MASTER DEVELOPMENT PLAN

LUCKEY RANCH  
SAN ANTONIO, TEXAS

MDP # 858

## Master Development Plan Review

MASTER DEVELOPMENT PLAN  
LUCKEY RANCH  
SAN ANTONIO, TEXAS

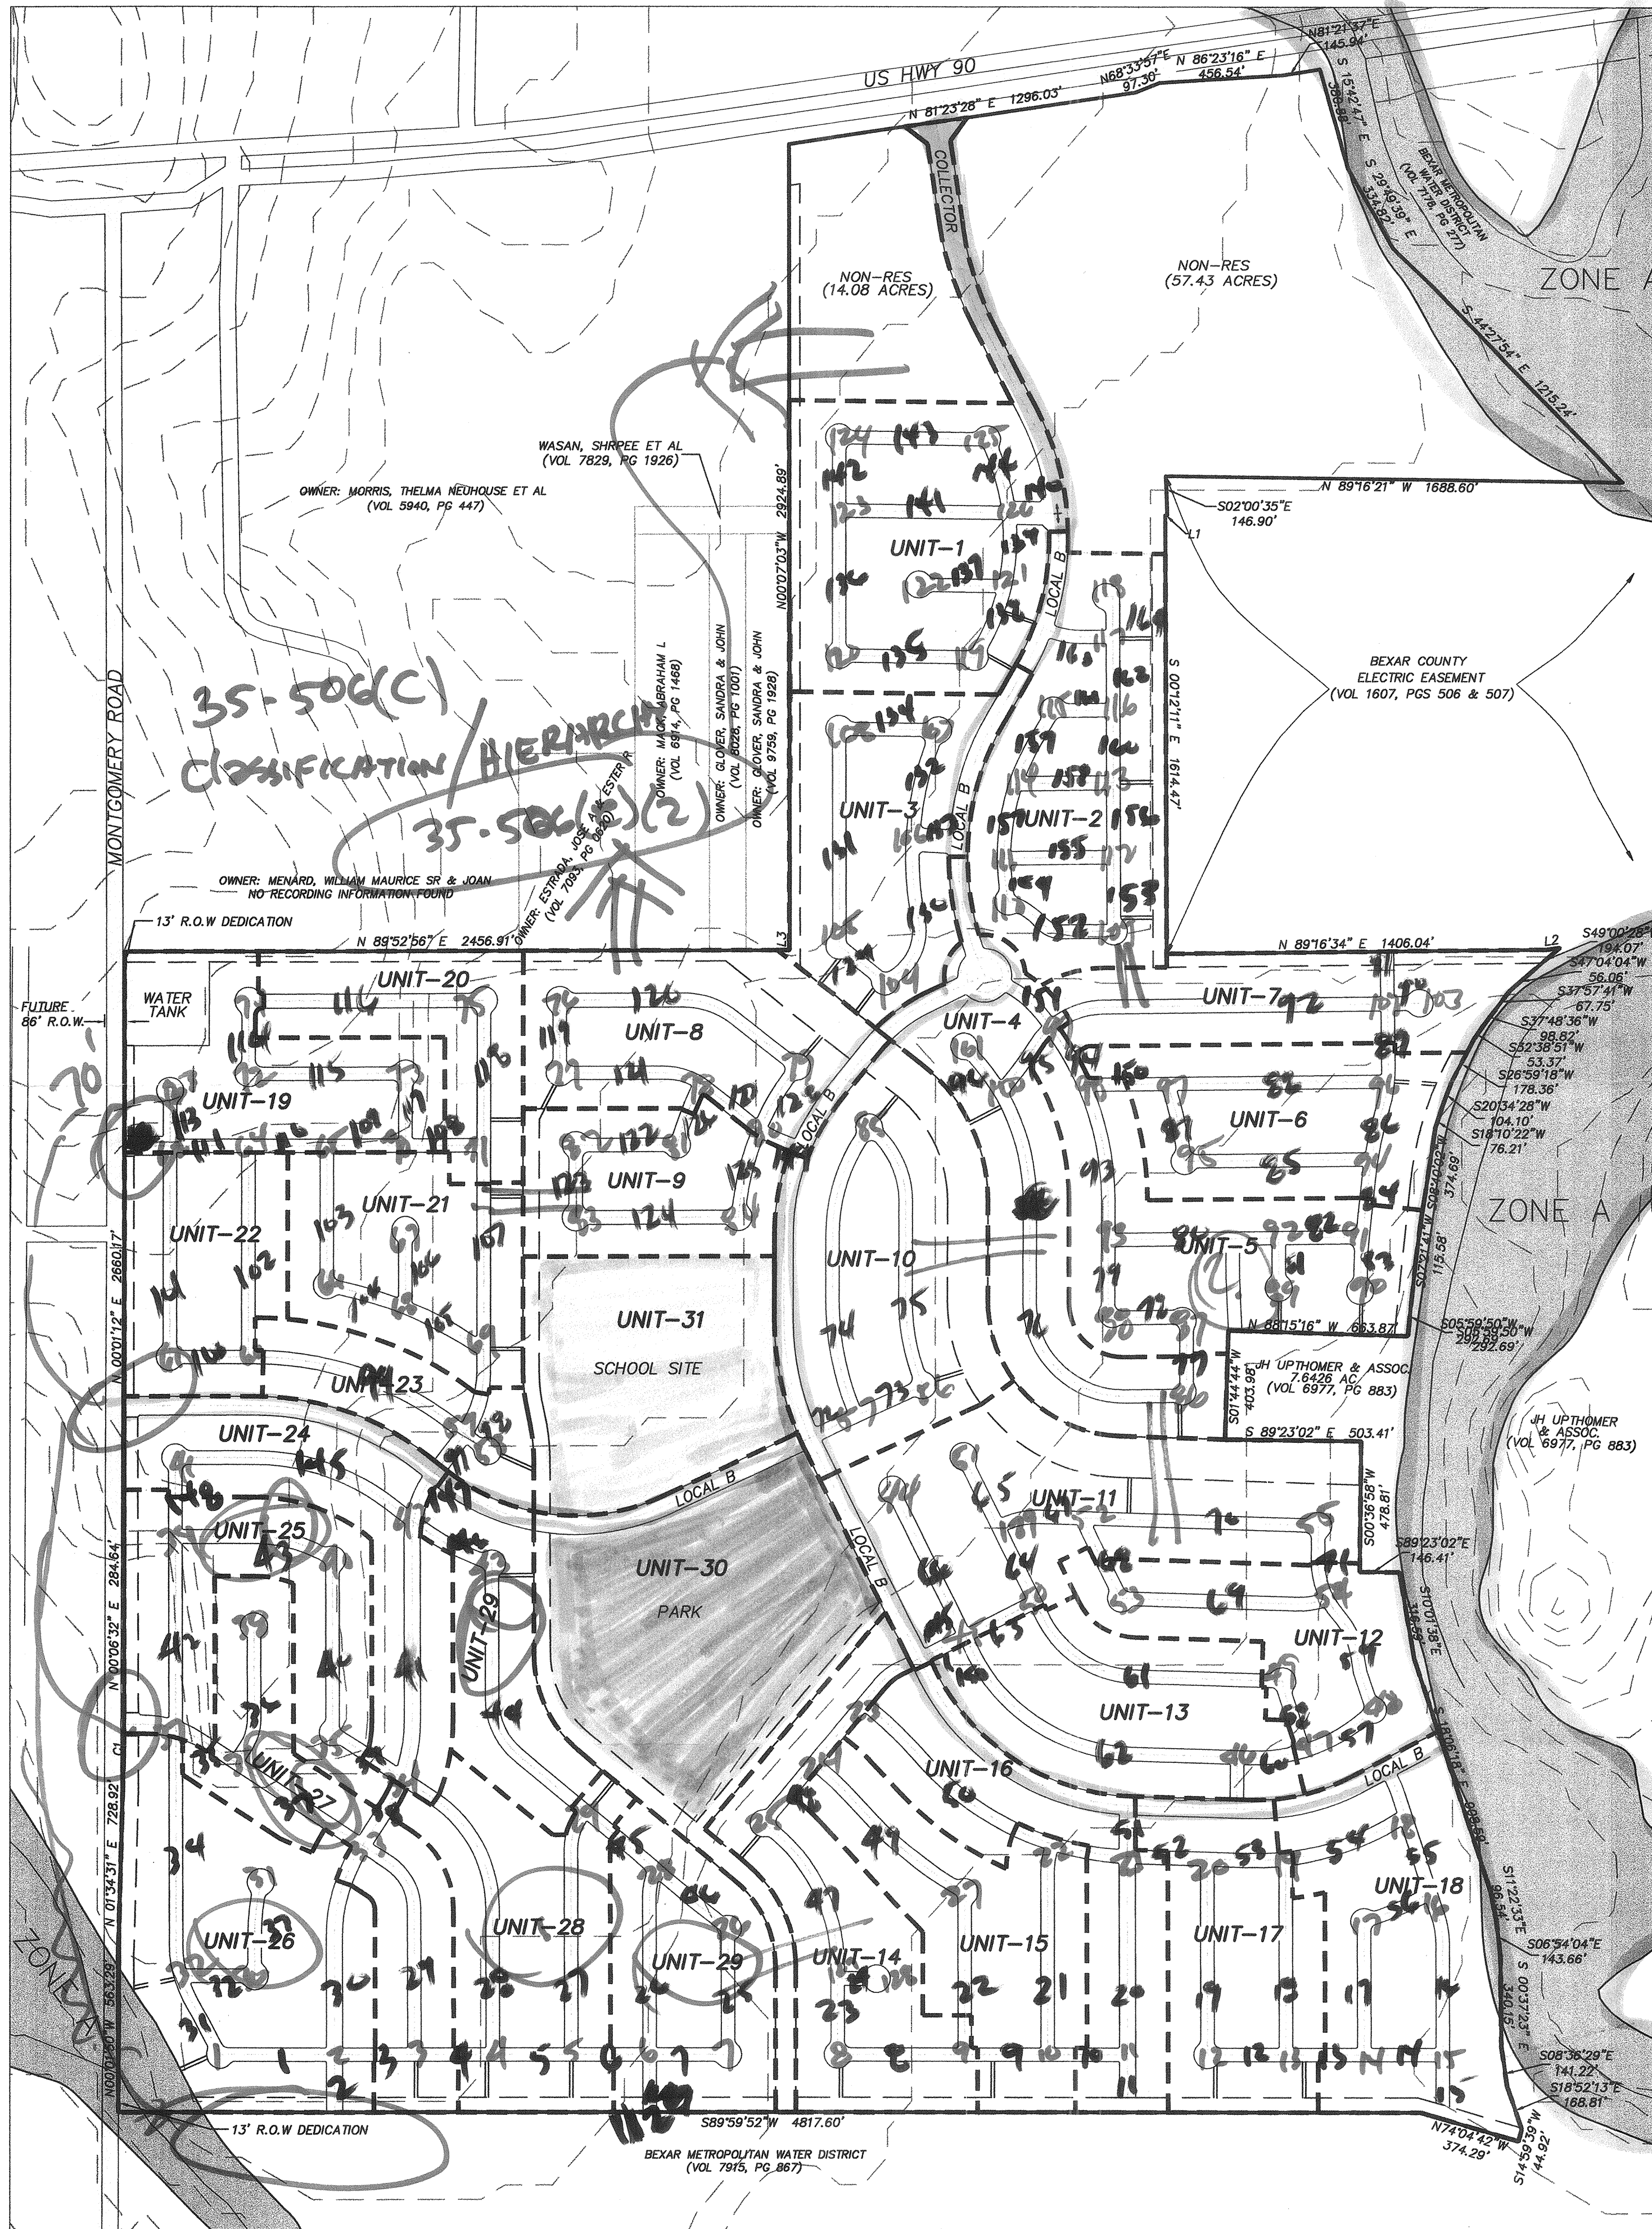
- The Local "B" road serving Units 5 and 6 shall be a full 60' ROW with 40' of pavement for two complete blocks prior to transitioning to a Local "A".
- The frontage road intersections along Montgomery Road will require mitigation for traffic signals (when warranted and approved by Bexar County Traffic, Public Works – Traffic and TxDOT) as per UDC 35-502, (7) Limitations on Traffic Impact Analysis, C. All street locations are identified in the approved Master Development Plan. Traffic signals shall

1. The above referenced MDP is approved with the following conditions:
  - a. Add a note stating that all intersections shall comply with clear vision area requirements in accordance with UDC Section 35-506(d)(5).

- b. Add a note stating that block lengths shall comply with UDC Section 35-515(b)(3).
  - c. Modify Note 2 to read, "sidewalks shall be provided in accordance with UDC Section 35-506(q) on internal and adjacent streets.

- g. Dead-end streets cannot exceed 150 feet in length unless a turnaround is provided.
2. It should be understood that this is a general review of a conceptual plan and that **all** technical requirements of the Unified Development Code for Streets & Drainage shall be complied with.

Proposed plan need to address UDC 35-506(c) Class./Hierarchy of roadway - 70' Collectors are required at arterials, Local B street type ADT's appear to require a 70' collector - will need TIA/Streets review and approval

- Proposed plan need to address UDC 35-506(c) Class./Hierarchy of roadway;
  - 70' Collectors are required at arterials - north and south Local A streets at Montgomery Thoroughfare as ID by MTP
  - N/S Local B street type ADT's appear to require a 70' collector instead of a Local B - will require TIA/Streets review and approval.
- UDC 35-506(e)(2) projection of street into unplatted areas north of unit 8 or 20 and or west of unit 1 or 3.
- UDC 35-506(e)(2) secondary access for units 5,6,and 7; unit 1; and unit 8 and 9.

No problem, we will add the note. The note requirement is consistent with other projects.

When we obtain the aerial topographic survey we will prepare a detailed flood study and submit it to stormwater for their review. If it occurs before final MDP approval and Stormwater concurs with the study, we can change the note.

COLLECTOR STREET SECTION

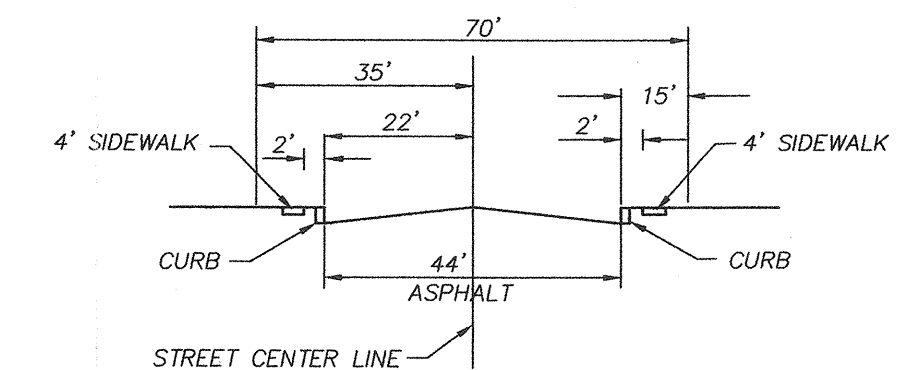
- e. On applicable street sections, the minimum 2-foot planting strip is measured from back of curb.
  - f. On Collector Street Section, clarify parkway dimension.

FED. ROAD DIV. NO.	FEDERAL AID PROJECT NO.			SHEET NO.
6				6
STATE	DIST.	COUNTY		HIGHWAY NO.
TEXAS	15	BEXAR		US HWY 90
R.O.W.		CONT.	SECT.	JOB
CONSTRUCTION		0024	07	
		0024	07

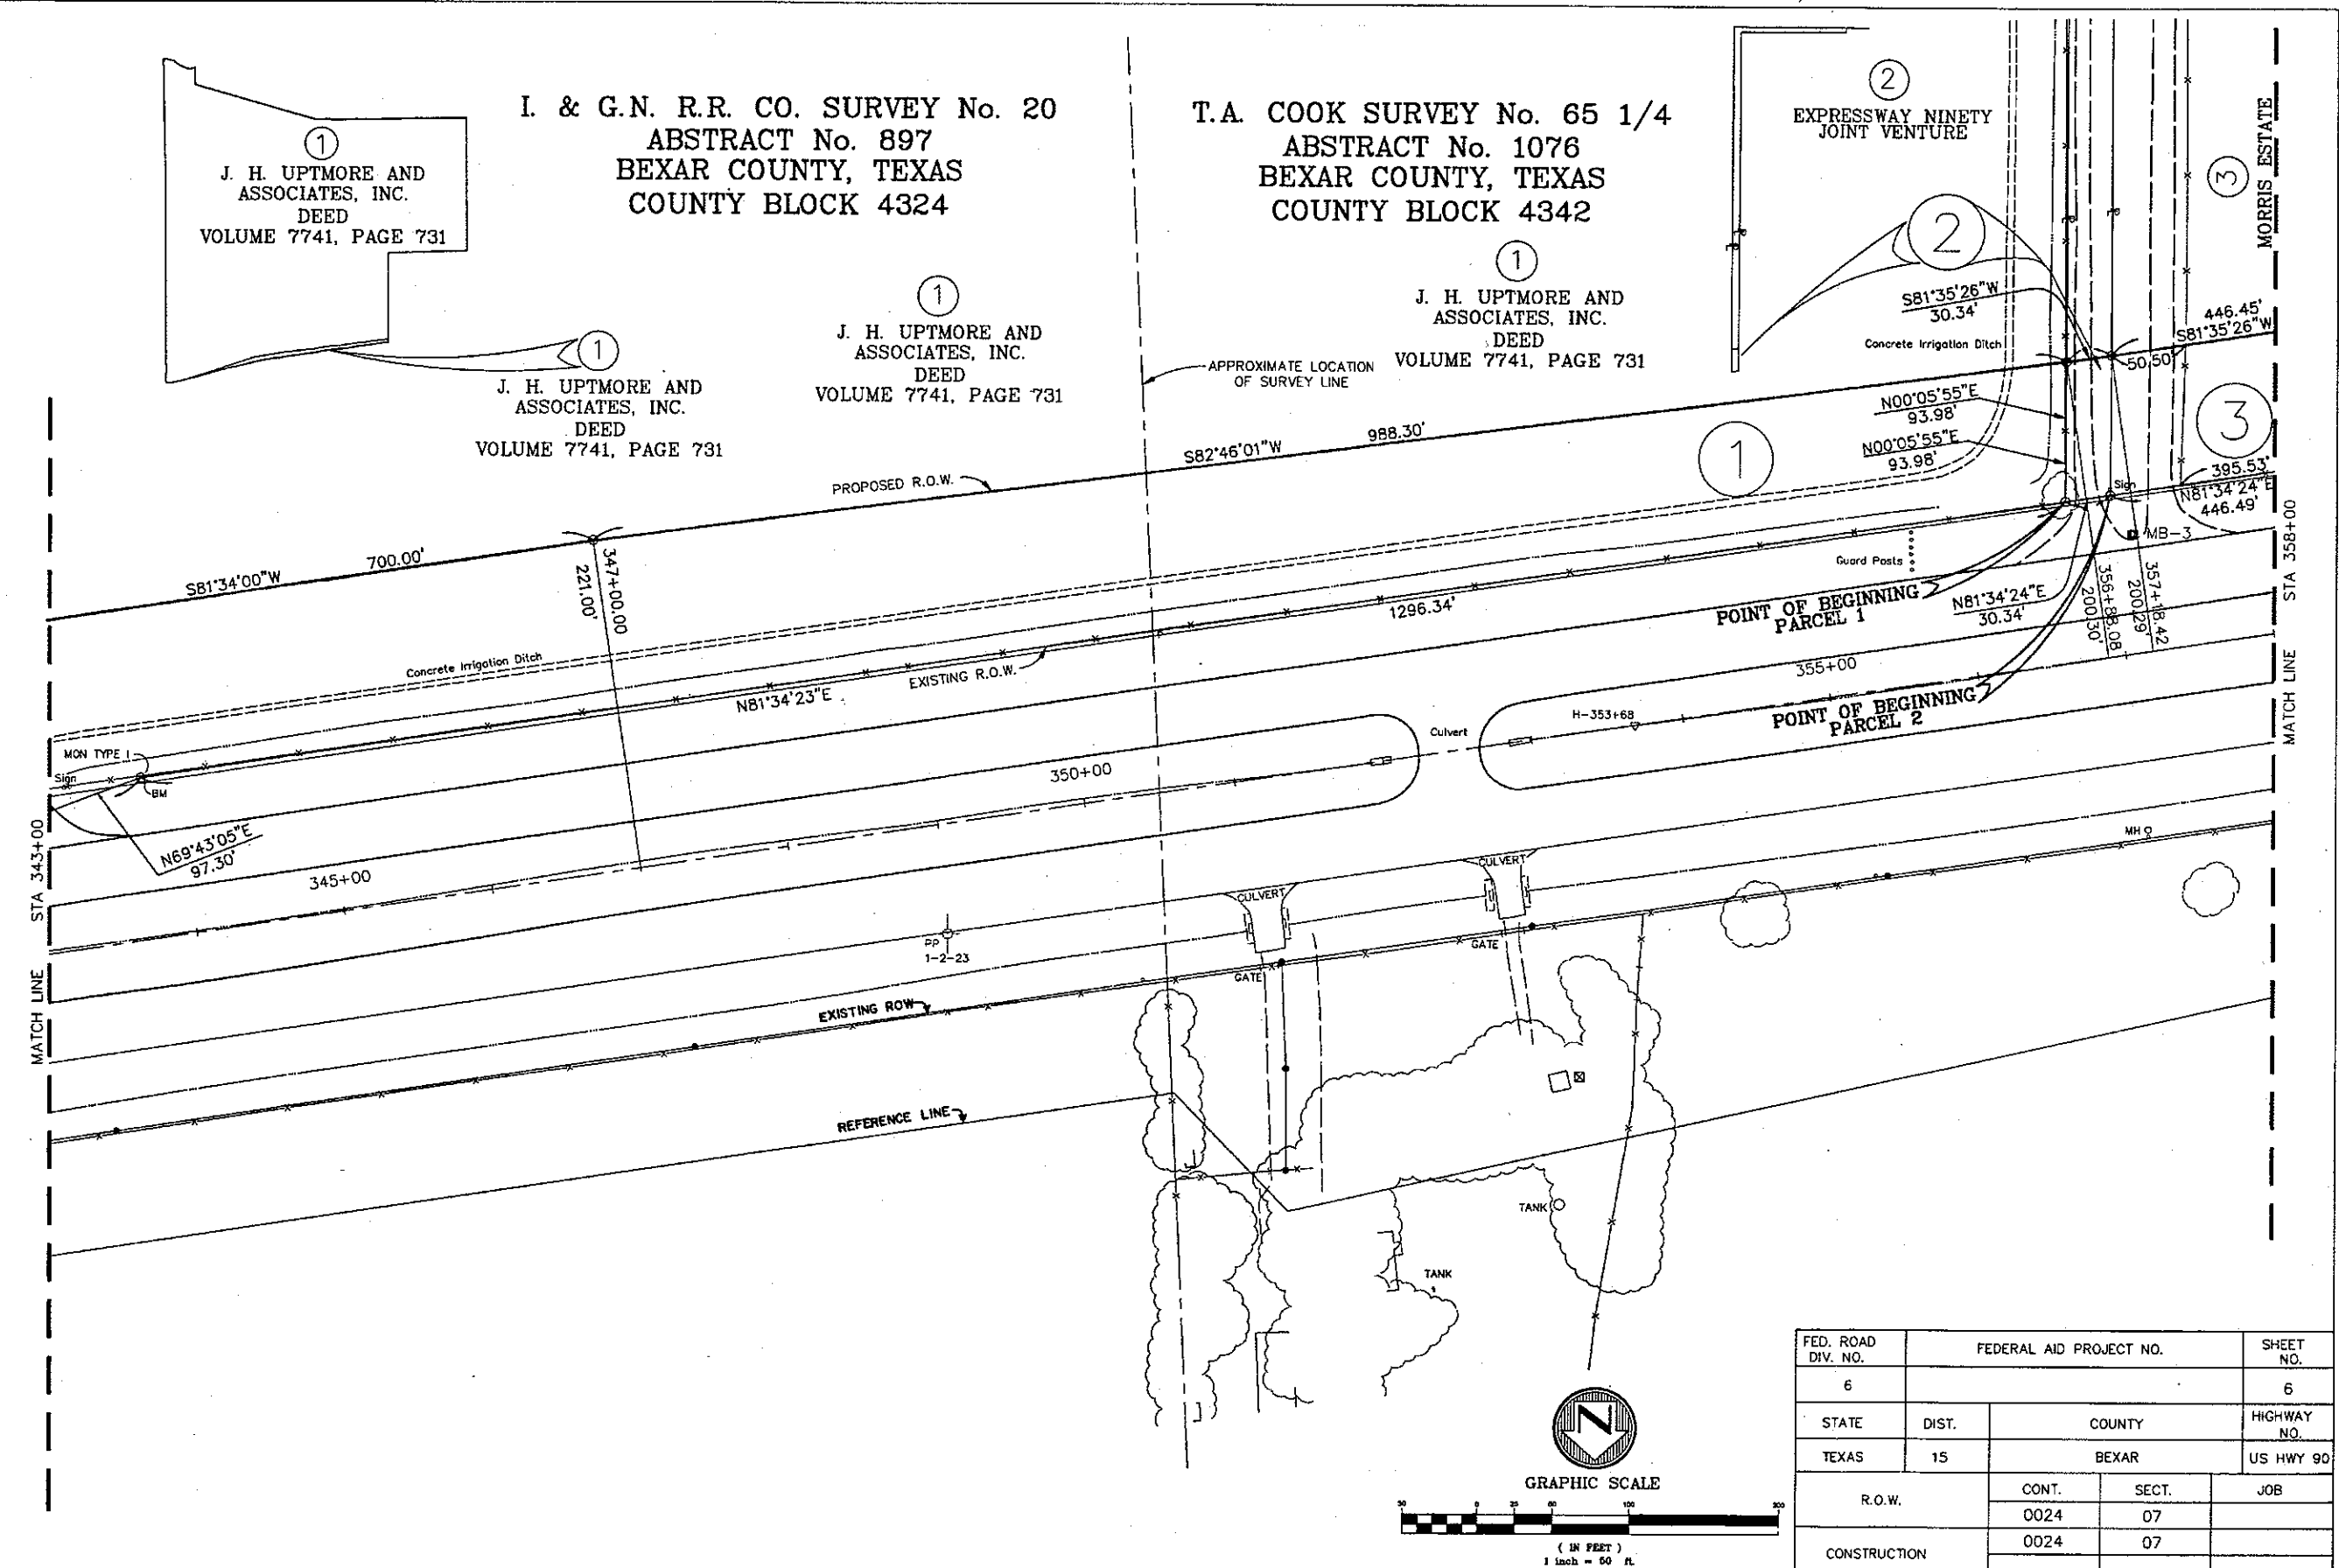
Future expansion of US 90 will provide continuous frontage roads from Loop 1604 to SH 211. Attached is a copy of the TxDOT right of way map depicting future right of way requirements. As a minimum, TxDOT recommends a reservation of the proposed future right of way requirements.
